**Site Location of Development**  
**TECHNICAL REVIEW MEMORANDUM**  
*Bureau of Land and Water Quality*

TO: **Donald Murphy, Project Manager, LURC**  
FROM: **David A. Waddell -- Division of Watershed Management** i  
DATE: **May 5, 2011**  
RE: **T16MD – Bull Hill Wind Project**

RE: Applicant Response to IF&W Review Comments - T16MD Bull Hill Wind Project DP#4886

*APPLICANT RESPONSE (ITALICS) TO IFW VERNAL POOL EMAIL COMMENTS  
OF MAY 12, 2011  
MAY 16, 2011*

Client/Project  
**Blue Sky East Wind, LLC**  
 Bull Hill  
 Eastbrook and T16MD, Maine  
 Figure No.  
**3**  
 Title  
**Delineated Natural Resource Map**  
 December 2010  
 rev. May 9, 2011

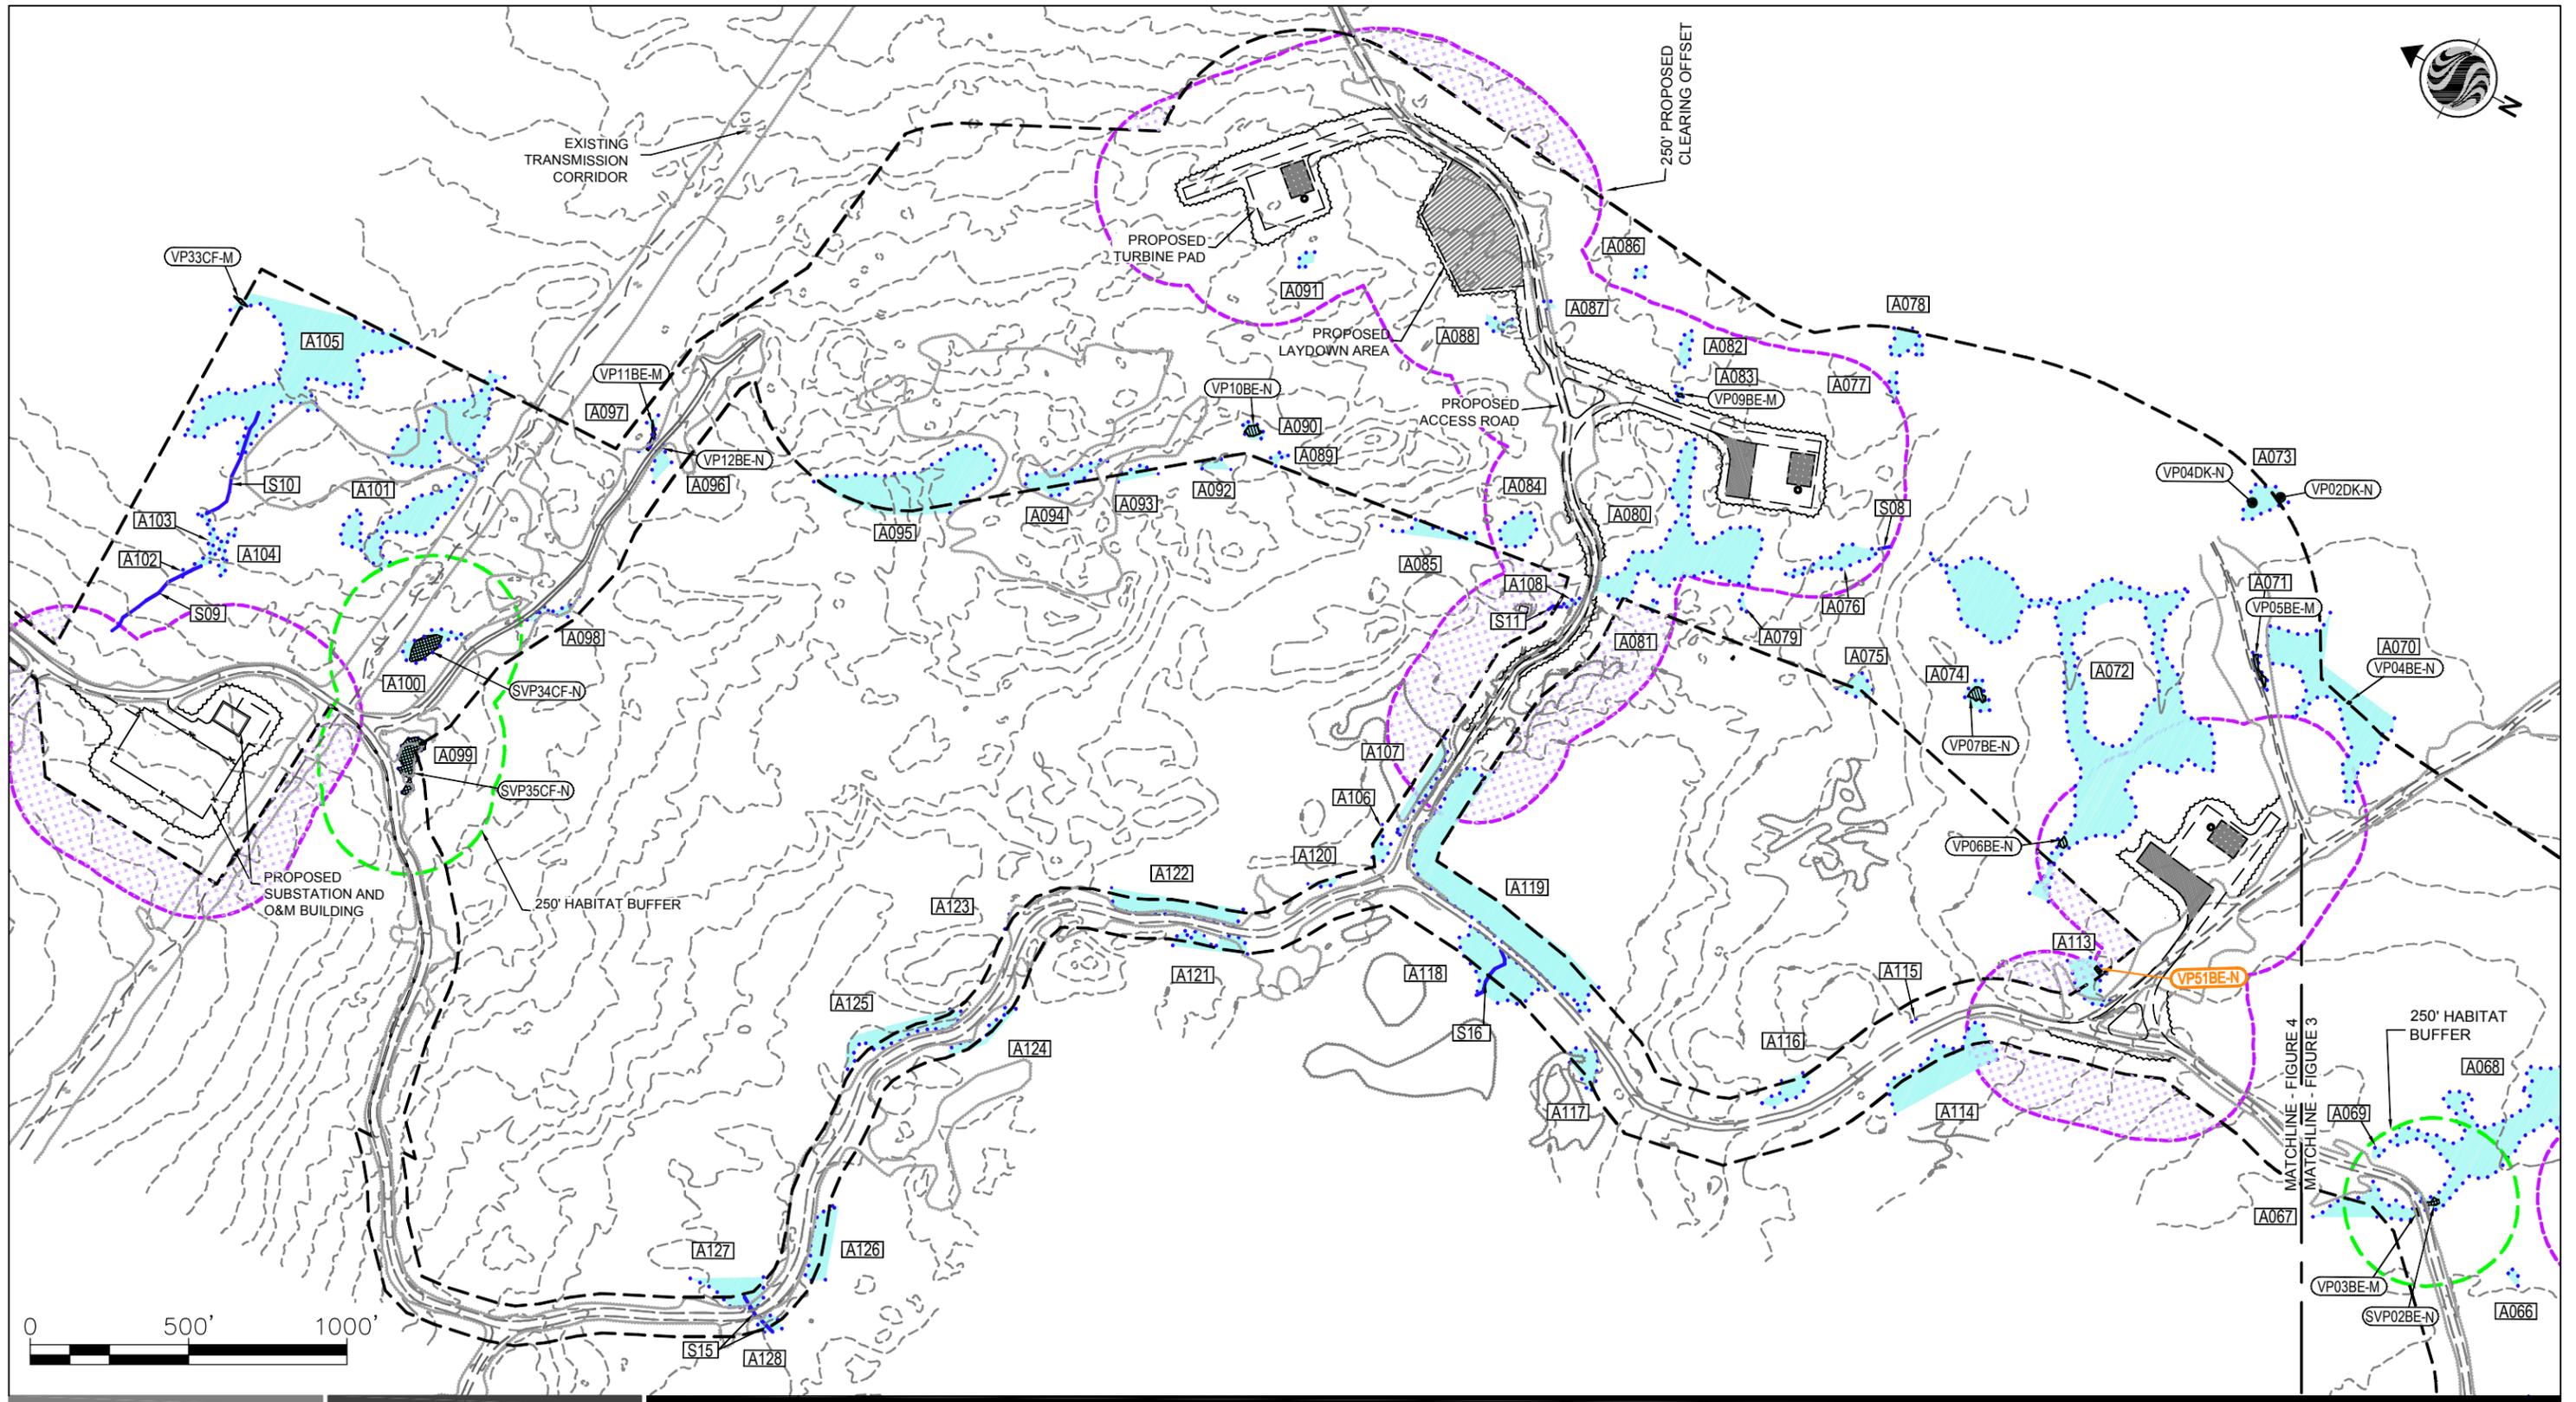
Without additional information from the applicant, MDIFW is unable to complete its review of potential project impacts to vernal pools or other wildlife resources. As currently defined, the project boundary does not sufficiently buffer the outside edge of existing or proposed development impacts to ensure that all resources of concern within 250' of a project activity are considered in the review.

2. MDIFW recommends that any existing roads bisecting SVP or PVP habitat (e.g., 11MG, 12MG, 9MG, 8MG on Map 3; SVP34CF on Map 4) that are not integral to the proposed wind facility infrastructure, and will no longer serve a forest management need, be closed/discontinued and allowed to revegetate to mature forest. If the current condition of these roads is not conducive to natural revegetation (e.g., wide cleared path, hard-packed surface, etc), the applicant should advance succession by softening/degrading the road surface and replanting with locally native tree species on 8ft x 8ft spacing. These plantings should be monitored for survival (ensuring a 75% survival rate of seedlings over a 5 year period) in order to facilitate recovery of a forested critical terrestrial life zone.

*All areas within 250 feet of any project clearing were surveyed subsequently to receiving this comment verbally from IFW. Three man-made vernal pools and one natural pool were identified (see attached figures 1, 3, and 4). None met the level of significance. The vernal pool form for the natural pool is attached.*

*There are no impacts proposed to any SVP depression, their surrounding critical habitat, or wetland impact associated with this project. The existing roads are forestry roads under the control of the landowner. In a zero impact project, there is no legal basis to require mitigation and, as noted above, IFW’s recommendation creates a disincentive to minimize a project footprint through use of using existing roads.*
